GOVERNMENT OF THE DISTRICT OF COLUMBIA
DISTRICT DEPARTMENT OF TRANSPORTATION

MEMORANDUM

Date: May 23, 2007

Subject: ZC 05-35 – Consolidated PUD and Zoning Map Amendment
Stanton Square - Stanton and Pomeroy Roads, SE

ATTACHMENT - A

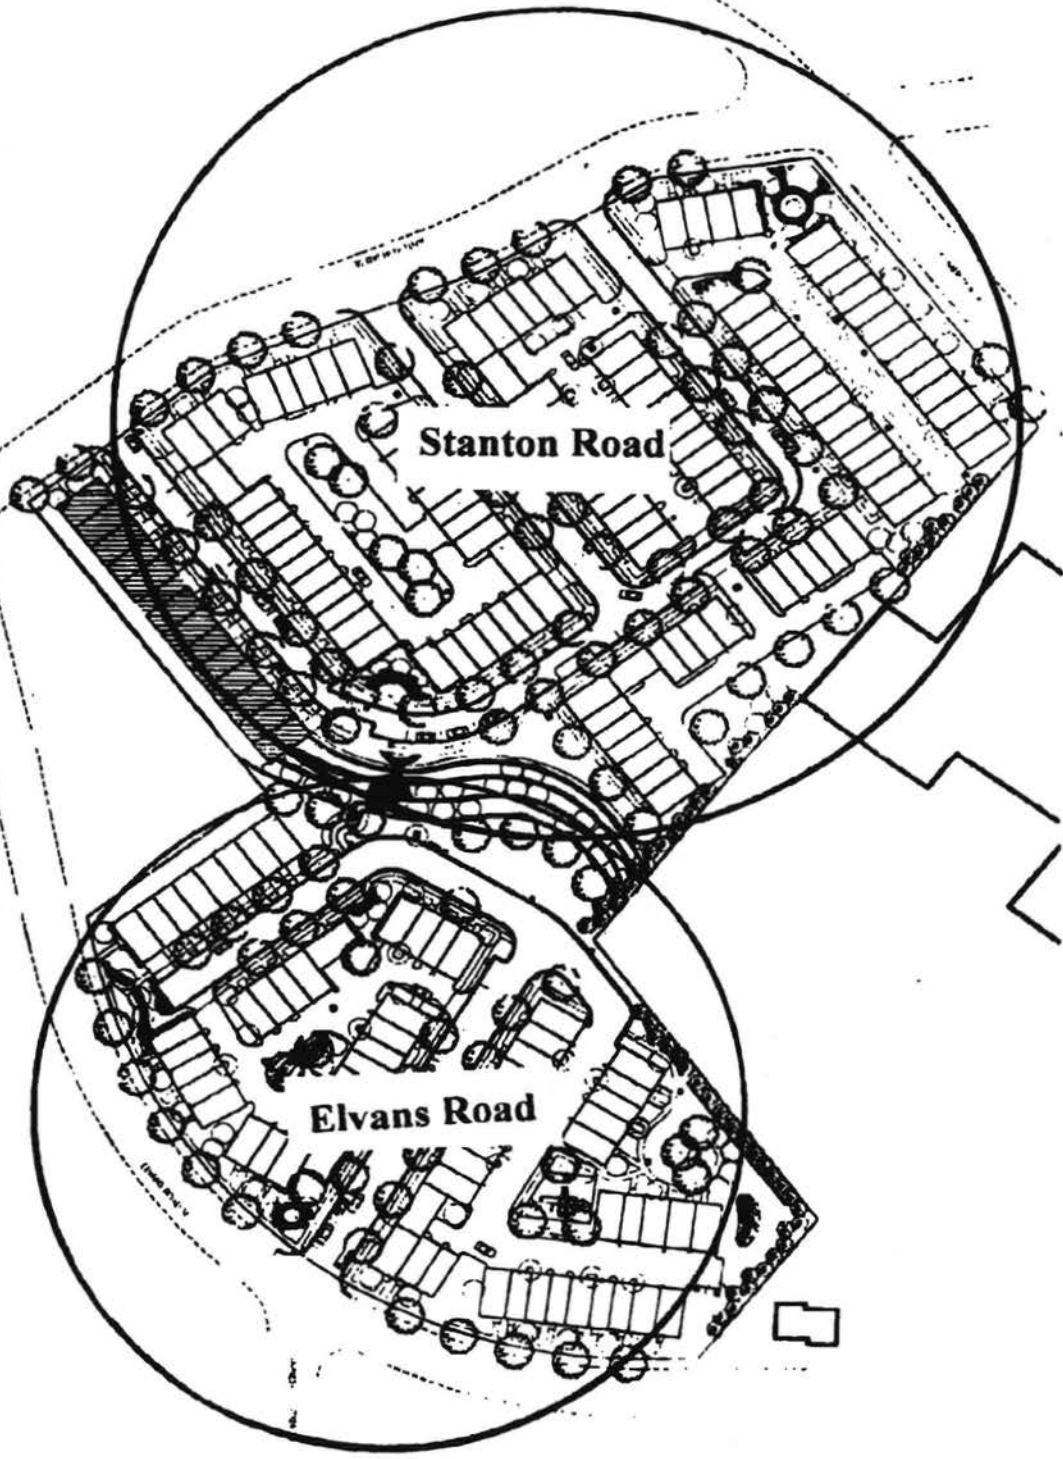
A total of four access points link the project to the adjacent road network with one off Elvans Road, SE across from Gainesville Street, SE, and three access points off Stanton Road, SE. For the purposes of this report the project is separated into two areas linked by a pedestrian walkway, designated the Stanton Road and Elvans Road portions of the project based on public roads providing direct access to each area. (Attachment - A)

ATTACHMENT – B

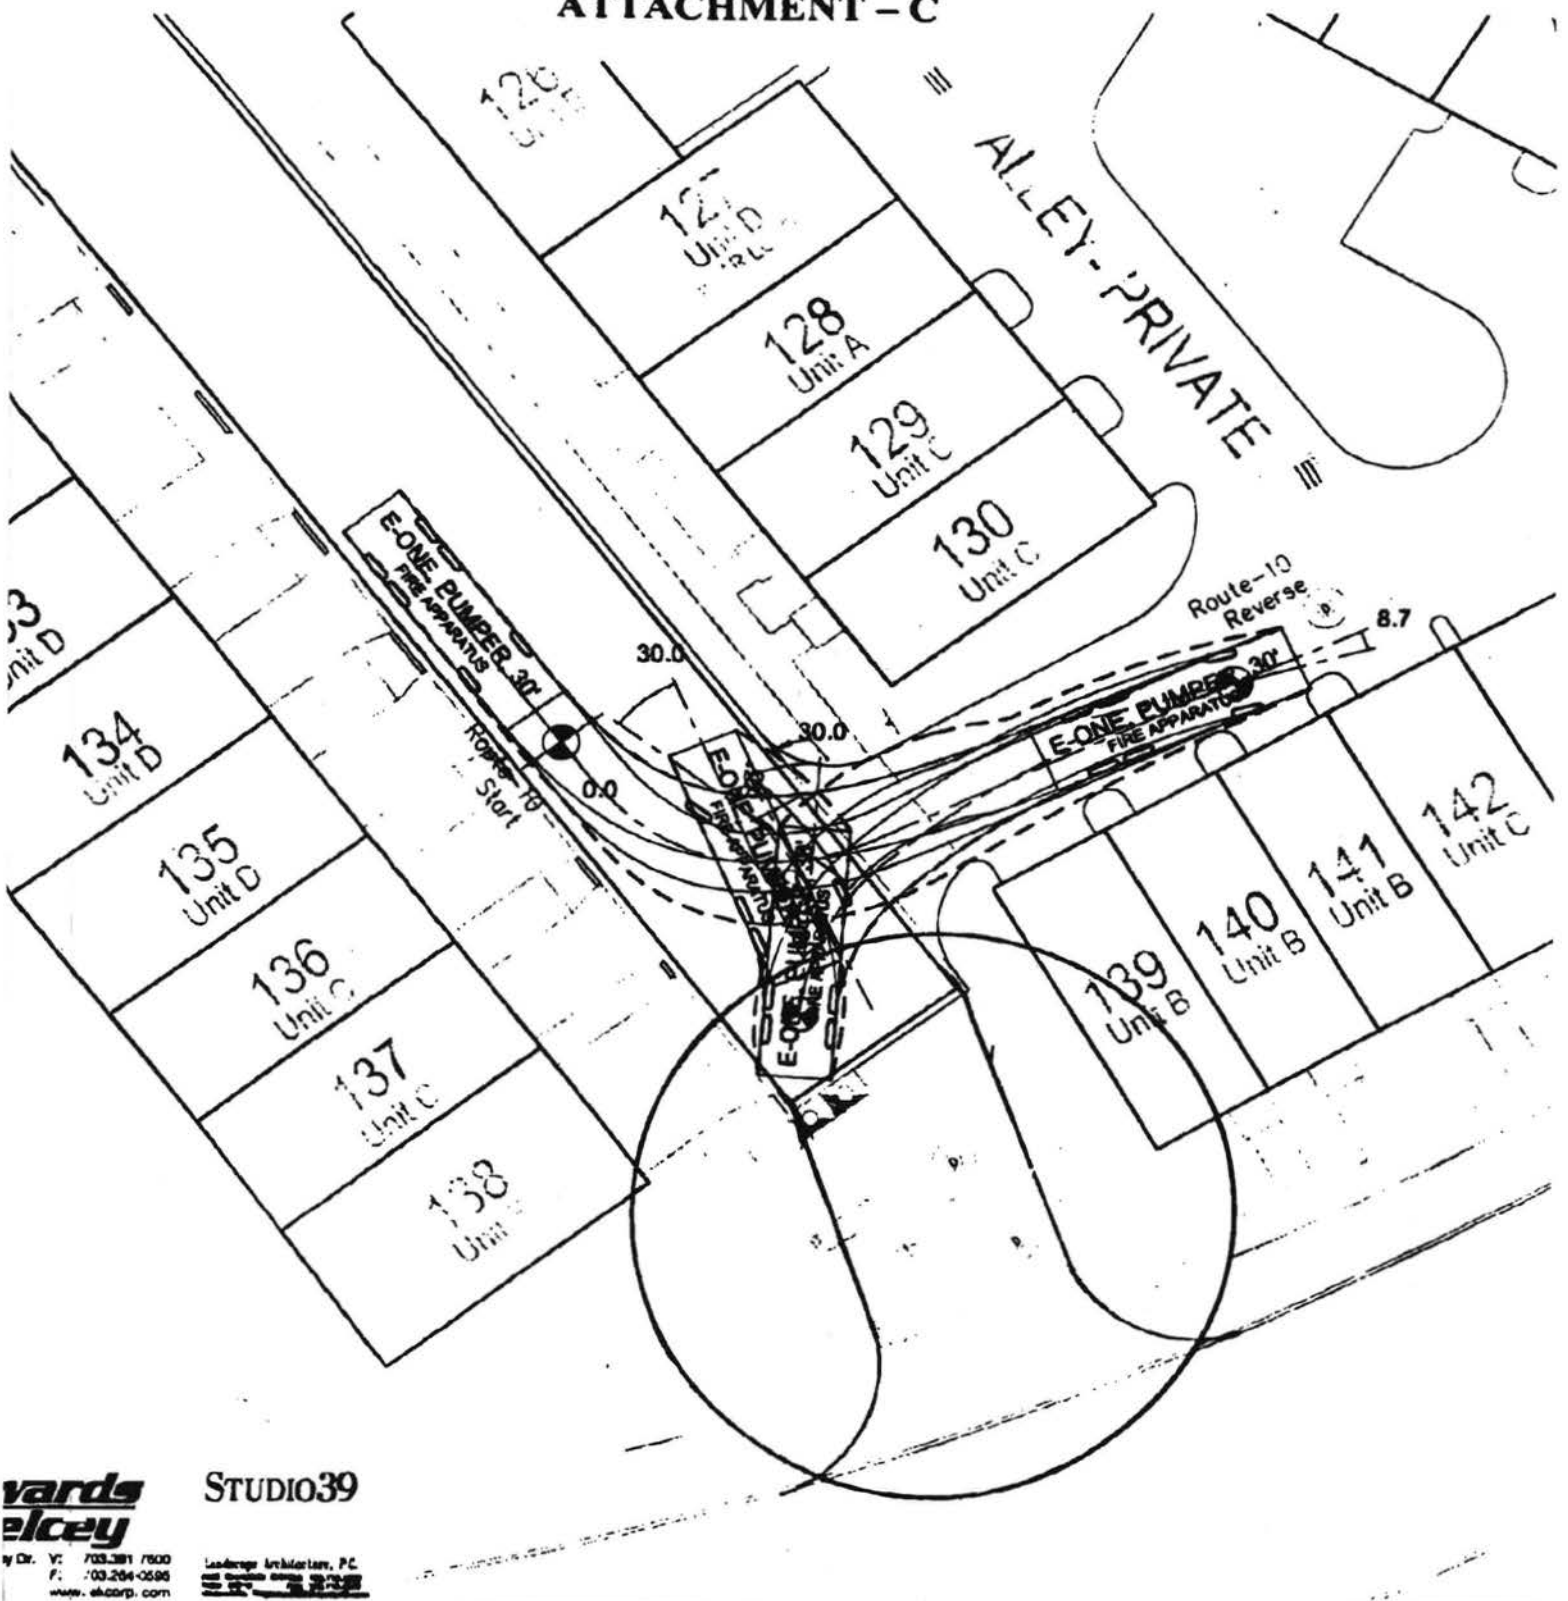
DDOT supports this position and recommends the applicant also design and construct the proposed private alleys to DDOT design standards and dedicate them as public alleys. This action will reduce the burden and overall costs for homeowners for maintenance of public areas as DDOT and the District will then become responsible for future repairs to sidewalks, roadways, signage, streetlights, etc. Designing and constructing the streets and alleys will become a one-time expense for the applicant that can be incorporated into the project cost. The proposed new roadways and alleys must be constructed to DDOT standards to be accepted and dedicated as public roads and right-of-ways; in addition DDOT will not accept any construction in public space that does not meet the minimum design criteria for construction. Unfortunately, current District Code requires a minimum 55 ft. R-O-W for one-way streets and a 75 ft. R-O-W for two-way roads; with 10 ft. setbacks on both sides of the roadway. (Attachment - B) These minimum design criteria are used to ensure safe movements of pedestrians and vehicles while also providing landscaping between the roadway and the property lines. The applicant proposal for R-O-W widths varying from 35 ft. for the one-way roadways to 47 ft. for the proposed two-way roadway cannot be approved until this section of the DC Code is amended.

ATTACHMENT - C

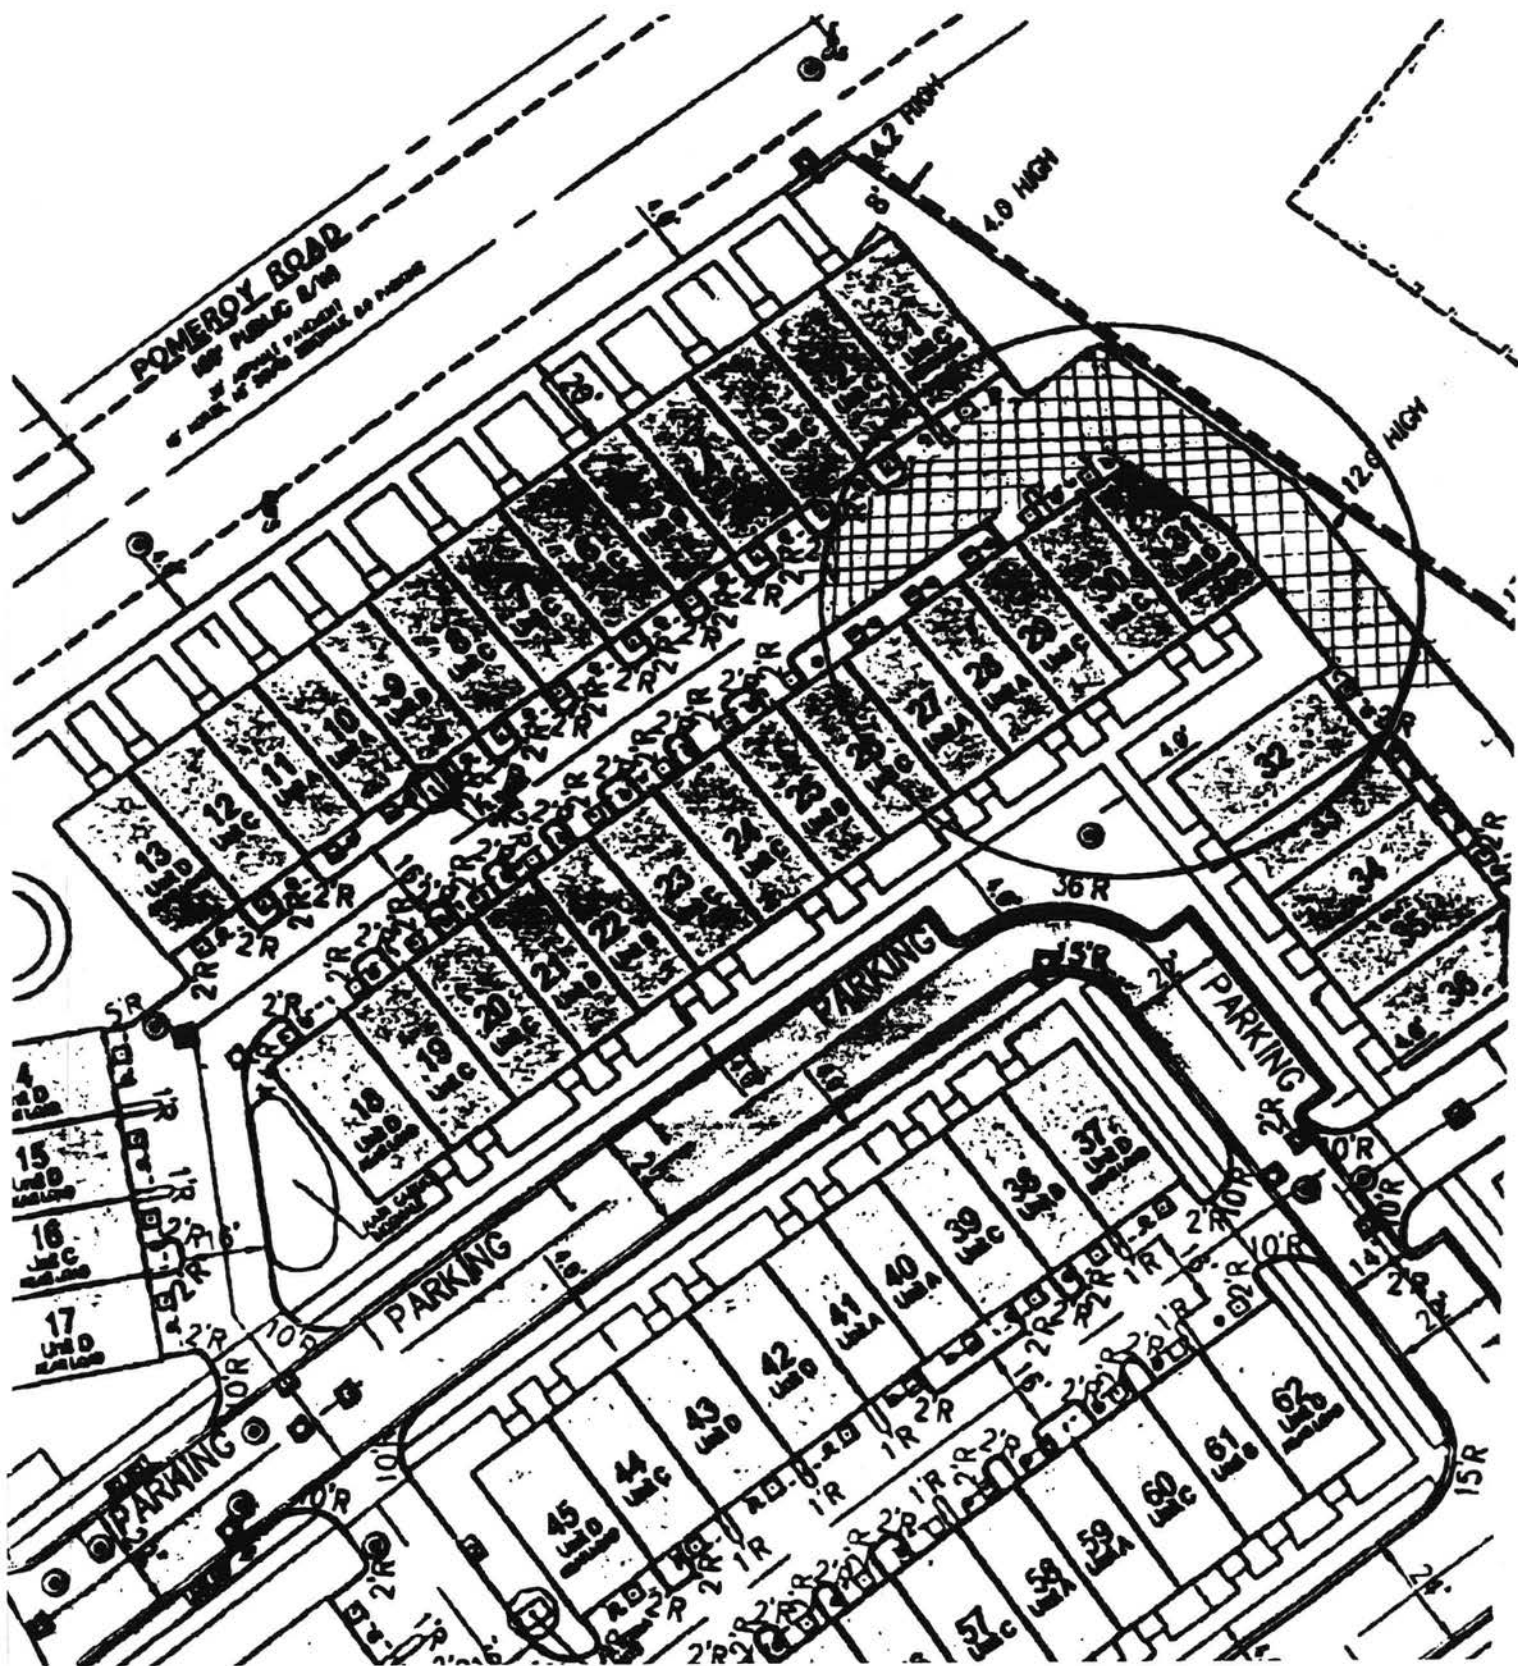
Vehicle circulation within the site is restricted by alleys and roadways that do not connect to streets and dead-end without appropriate areas for vehicles to turn-around. The applicant submitted vehicle tracking diagrams that show the turning for 35 ft. long trash collection trucks, WB-40 tractor trailer trucks and fire trucks. The circulation plan shows both trash and fire trucks heading-in and backing-out of some of the alleys because they dead-end, often crossing private property lines and the curb. The alley system is used to access almost all of the garages for the new town-homes and it is of critical importance that they are accessible at all times. Providing more connections within the site and to surrounding roads will improve overall circulation.

For the Stanton Road portion of the project DDOT recommends the applicant connect the proposed alley at the northwest corner of the site running parallel to Pomeroy Road, SE that ends between Unit No. 1 and Unit No. 31, to the proposed north-south alley ending at Unit No. 32. (Attachment - D *) Connecting these two alleys will allow trash trucks and snow removal vehicles to head-in and head-out of the alleys without making numerous turning movements, however Unit. No. 31 may have to be eliminated to accommodate this connection.
